ADDENDUM 3 – JOB 40

TO: All prospective bidders on project IM-8-029(132)078, Job No. 40 scheduled for the November 14, 2014 bid opening.

November 6, 2014

Type of Work: PCC RECONSTRUCTION, RAMP HBP MILL & OVERLAY, BRIDGE PIER PROTECTION, DRAIN BOX CULVERTS, CENTERLINE PIPES, GUARDRAIL, FENCING & INCID

Revised	11/3/14	STATE	PROJECT NO.	SECTION NO.	SHEET NO.
		ND	IM-8-029(132)078	130	1

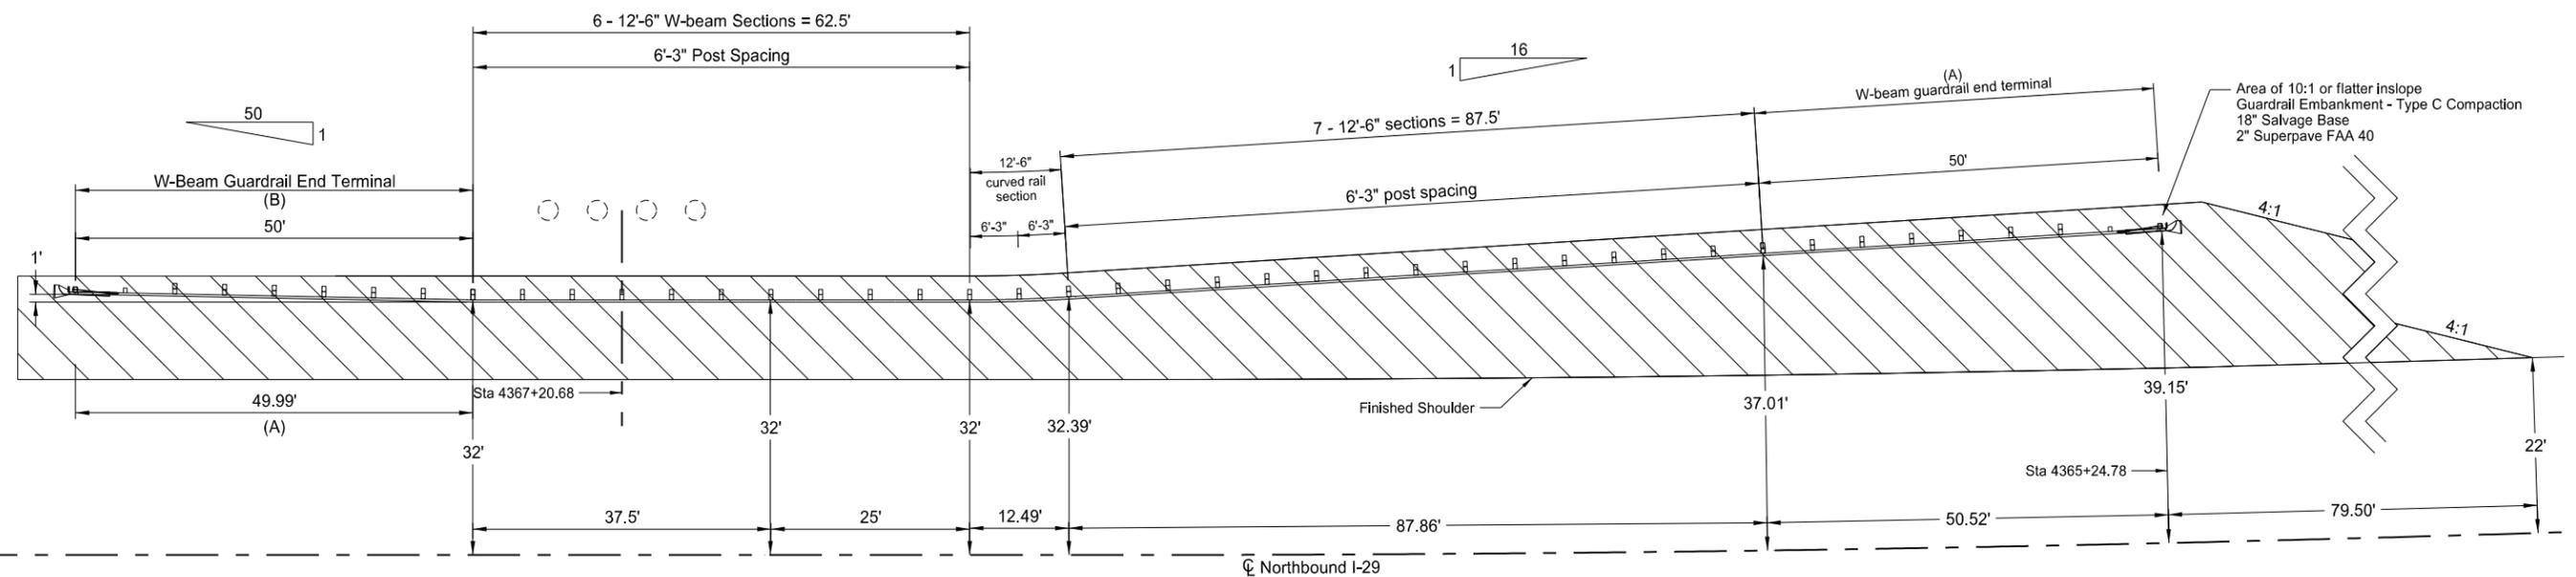
- Note (B) Revised to eliminate ET-2000 end terminal

Revised	11/3/14	STATE	PROJECT NO.	SECTION NO.	SHEET NO.
		ND	IM-8-029(132)078	130	3

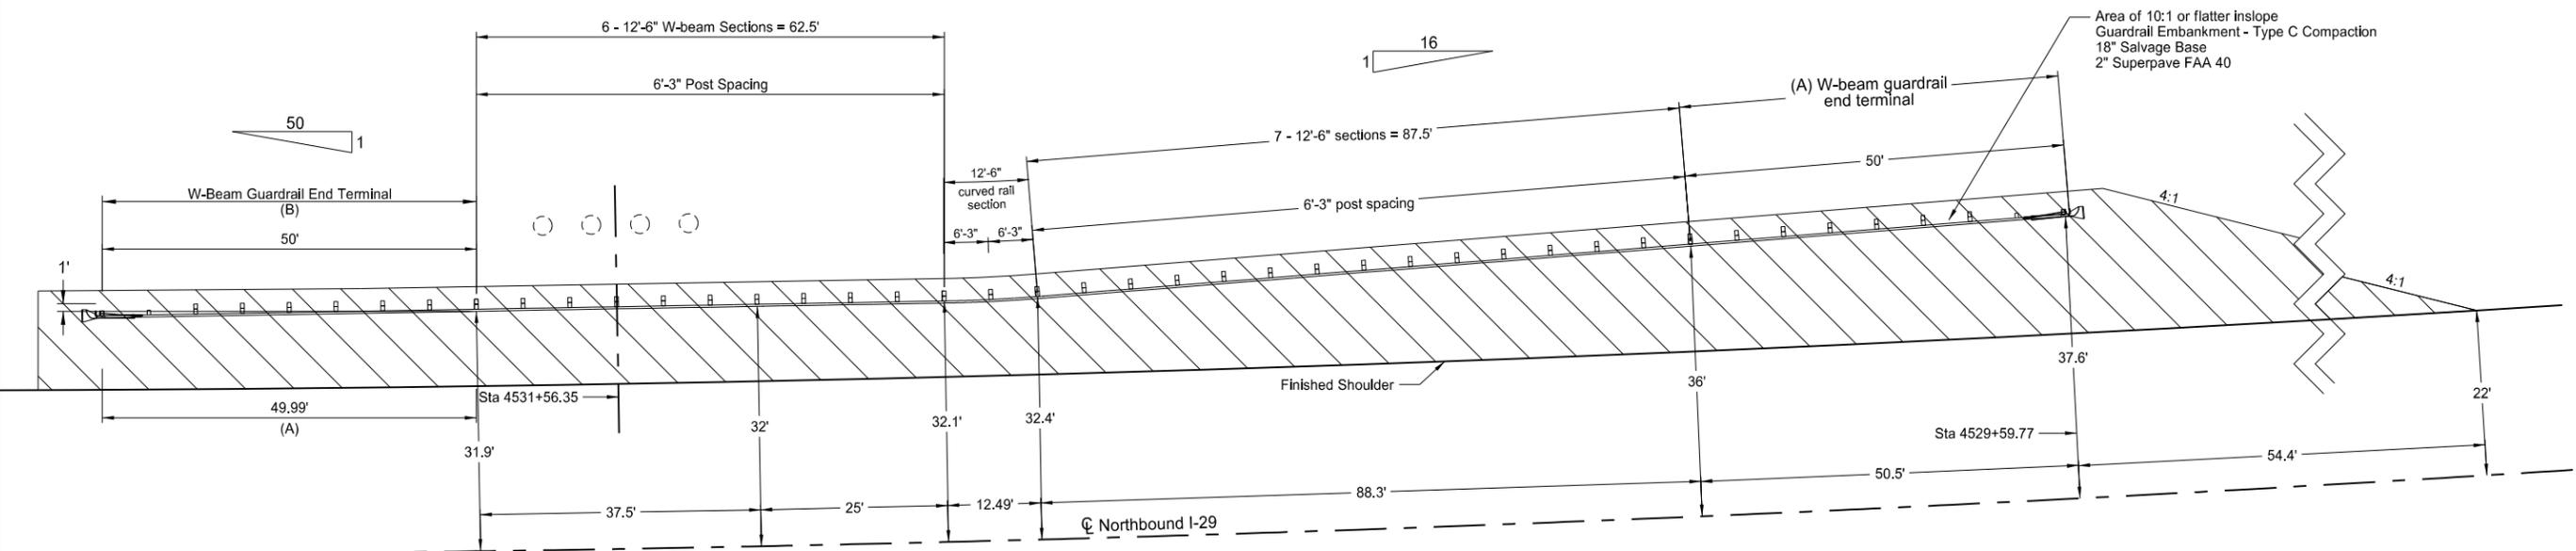
- Note (B) Revised to eliminate ET-2000 end terminal
